Comparison of “Draft of evaluation meeting report of Tsuruga Experts Meeting” and “JAPC’s opinion”

Response to comments expressed by the former Nuclear and Industrial Safety Agency during field survey on April 24, 2012

Fig. 7: K fault near western pit of D-1 trench

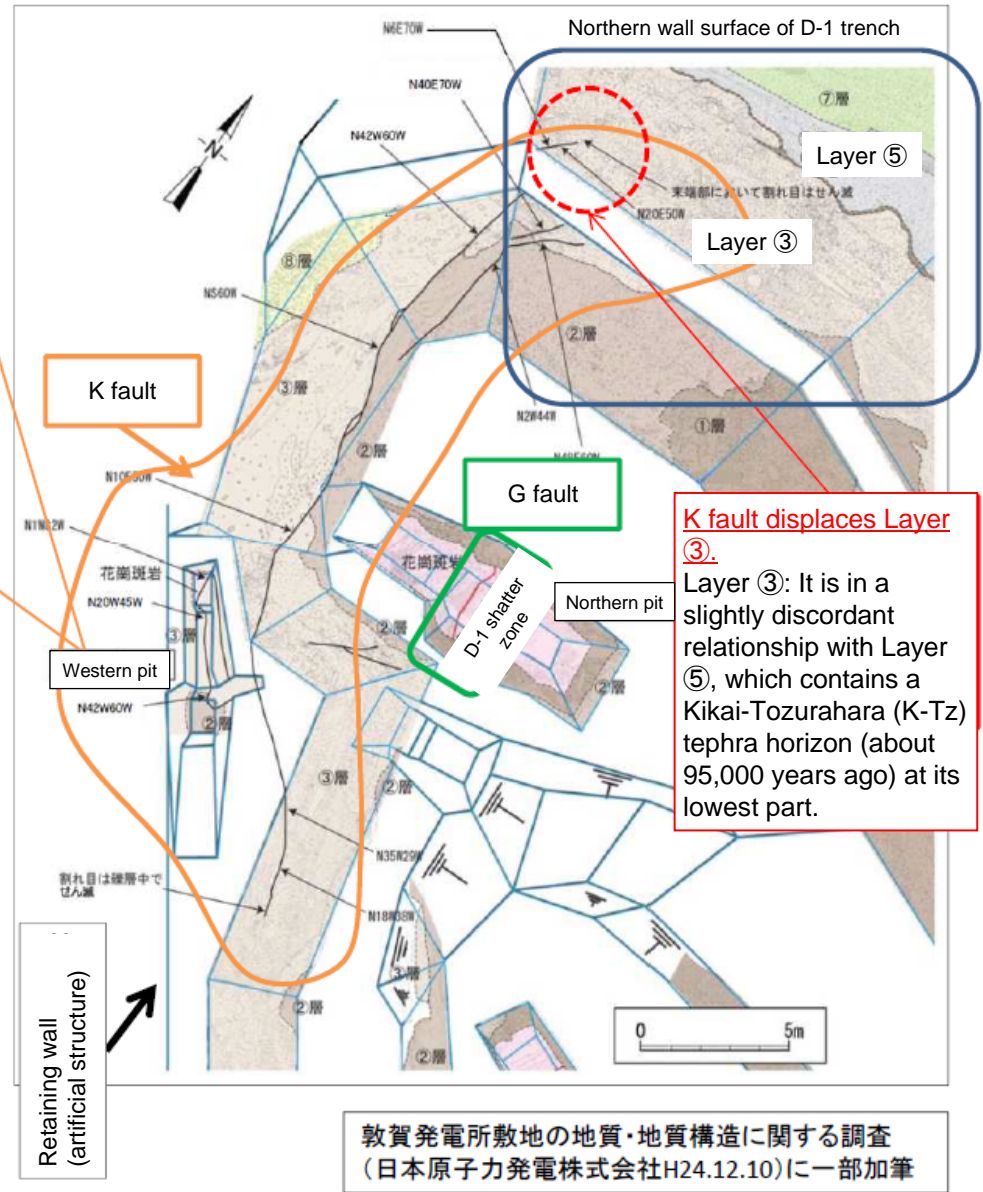
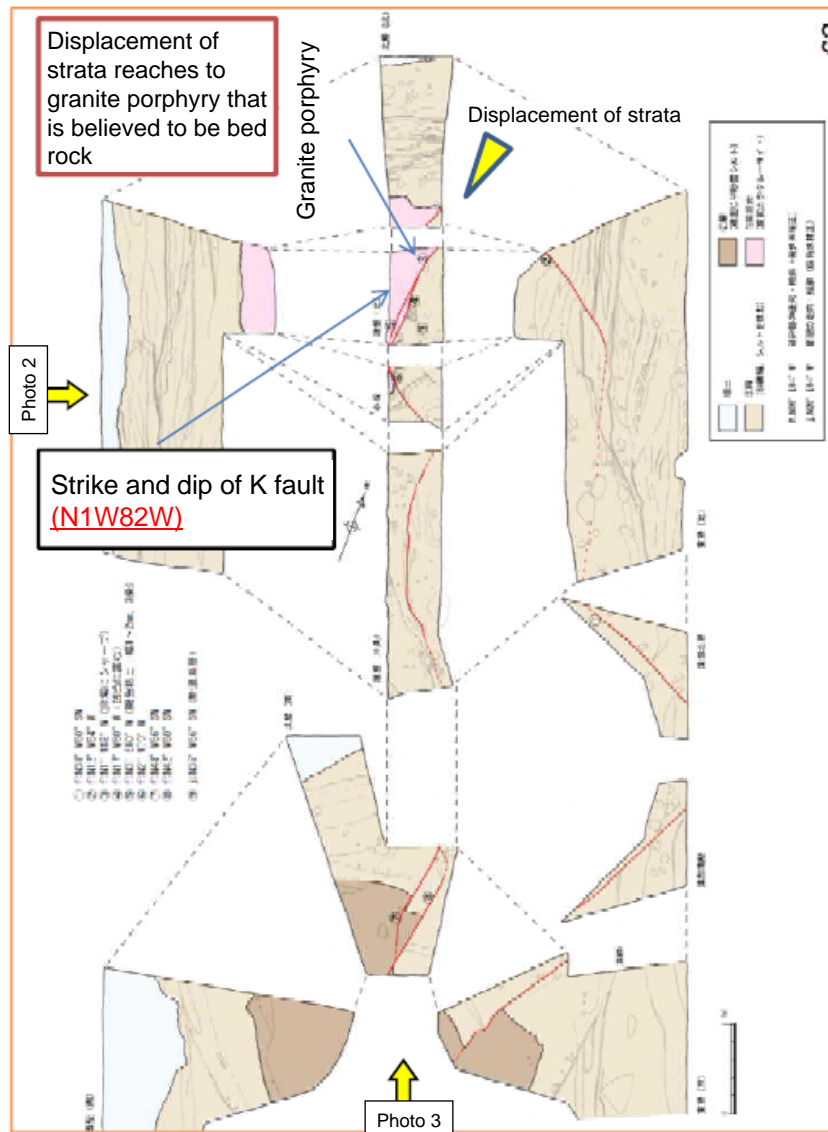
K fault displaces Layer ③.
 Layer ③: It is in a slightly discordant relationship with Layer ⑤, which contains a Kikai-Tozurahara (K-Tz) tephra horizon (about 95,000 years ago) at its lowest part.

K fault and D-1 shatter zone	<p><u>K fault would be D-1 shatter zone or a part of extension thereof.</u></p> <p>Grounds:</p> <ul style="list-style-type: none"> K fault is located close to the fault defined as D-1 shatter zone. The strike and dip of K fault are similar to those of D-1 shatter zone. <p>Matters pointed out by the second evaluation meeting It was pointed out that “if data that show significant changes in the strike of K fault are obtained in the future, it is necessary to review anew the relations between K fault and D-1 shatter zone.”</p>	<p><u>K fault is not D-1 shatter zone (including G fault).</u></p> <p>Grounds:</p> <ul style="list-style-type: none"> K fault extends into the rock mass, the direction of its strikes changes from N-S to NNW-SSW. From the observation on thin section, It has been confirmed that K fault and D-1 shatter zone has different displacement senses of the last slips. (K-fault: reverse fault with strike slip, D-1 shatter zone (including G fault): normal fault and right-lateral slip) K fault with reverse fault sense dose not extend to southern direction at least beyond B14-2 boring. <p style="text-align: right;">* Genesis of K-fault is under investigation</p> <p>* To grasp the shape and strike of K fault in detail based on the matters pointed out at the second evaluation meeting, a survey is being conducted by adding survey points around D-1 trench.</p>

Fig. 8: Relations between K fault and G fault

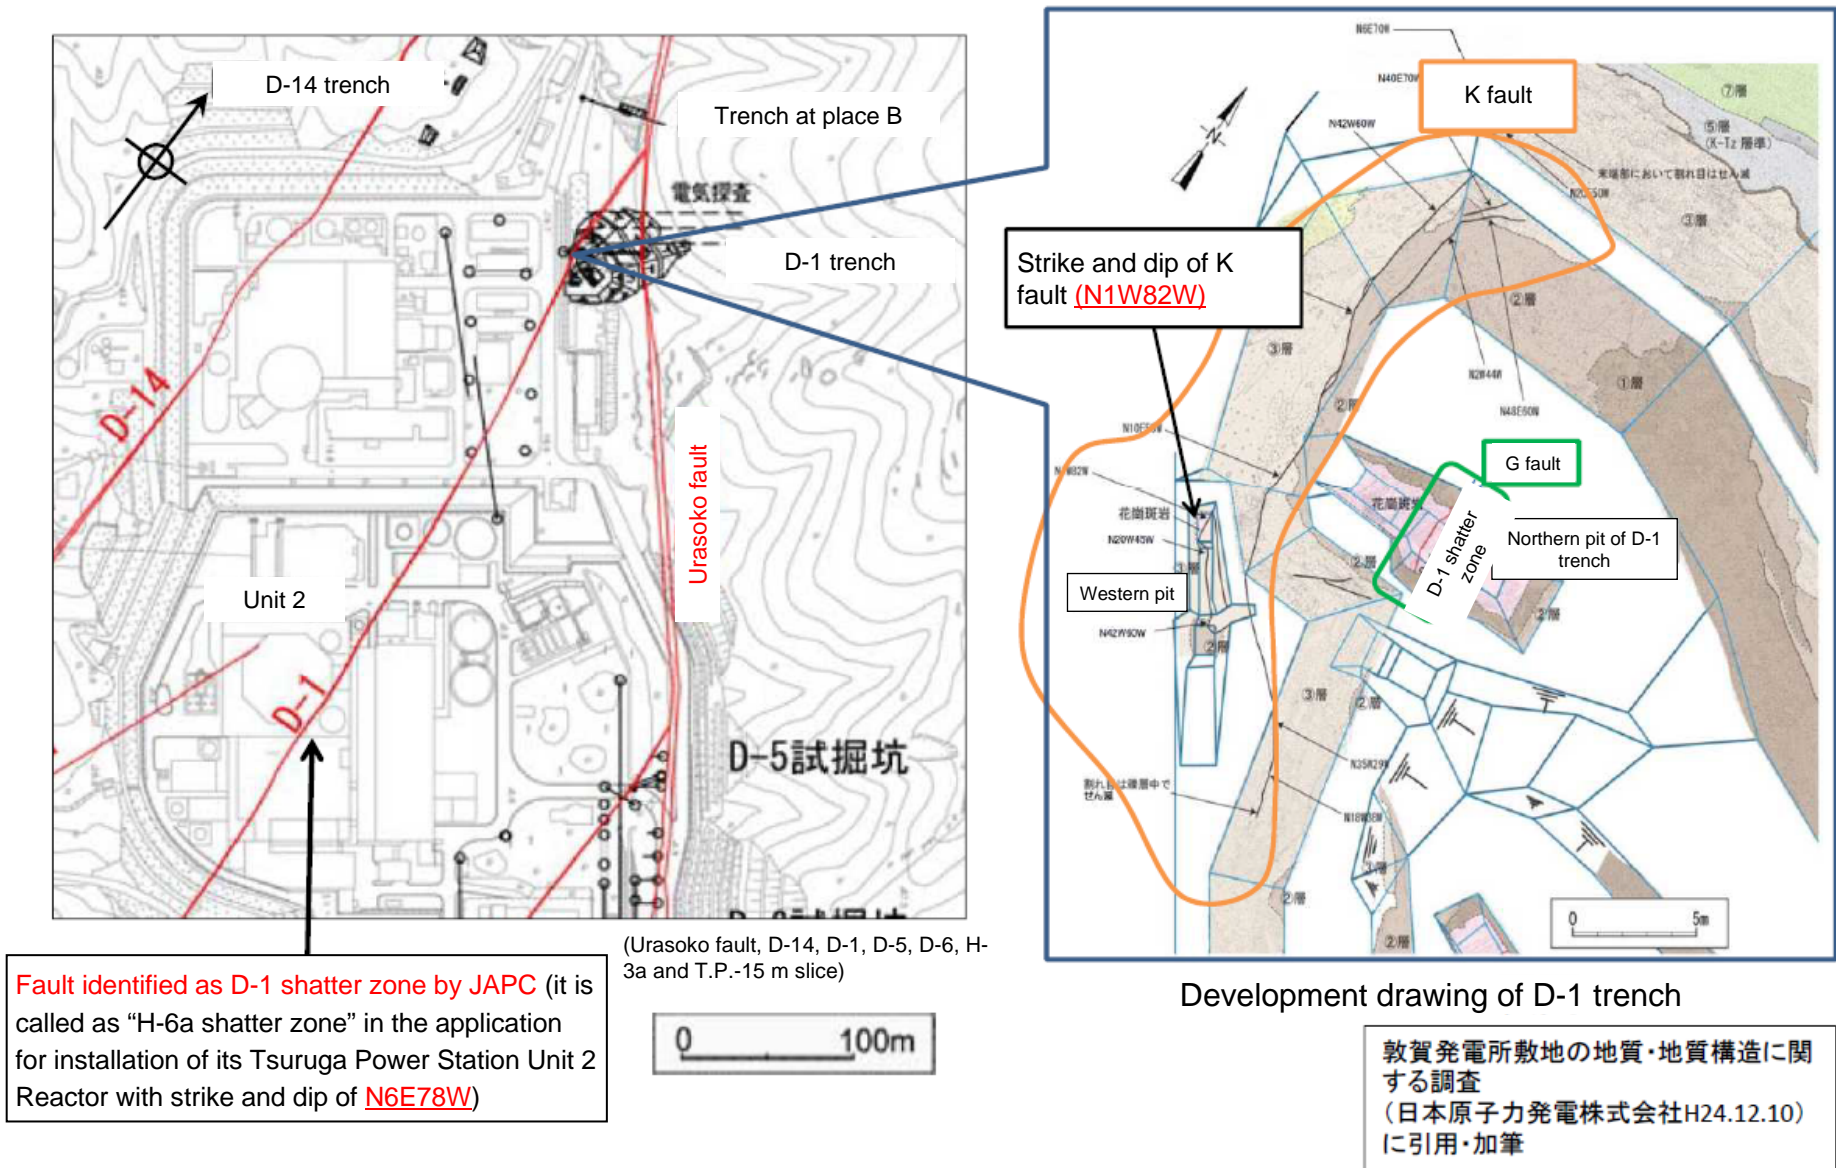
Item		Draft of evaluation meeting report of Tsuruga Experts Meeting	JAPC’s opinions
Continuity	G fault and D-1 shatter zone	<p><u>As the grounds used by the operator to define G fault as D-1 shatter zone are unclear, the activity of G fault cannot be used to evaluate the activity of D-1 shatter zone.</u></p> <p>Grounds:</p> <ul style="list-style-type: none"> The relation between G fault and D-1 shatter zone are unclear. 	<p><u>G fault is D-1 shatter zone.</u></p> <p>Grounds:</p> <ul style="list-style-type: none"> G fault has same strike and dip as D-1 shatter zone (N-S strikes, high-angle westerly dips) It has been confirmed at four points on the north side and south side of the reactor building that the vertical and horizontal displacement senses of the last slips consistently agree with the normal fault and right-lateral slip sense. <p>* To increase the density of survey data based on the matters pointed out at the second evaluation meeting, a survey is being conducted by adding survey points.</p>
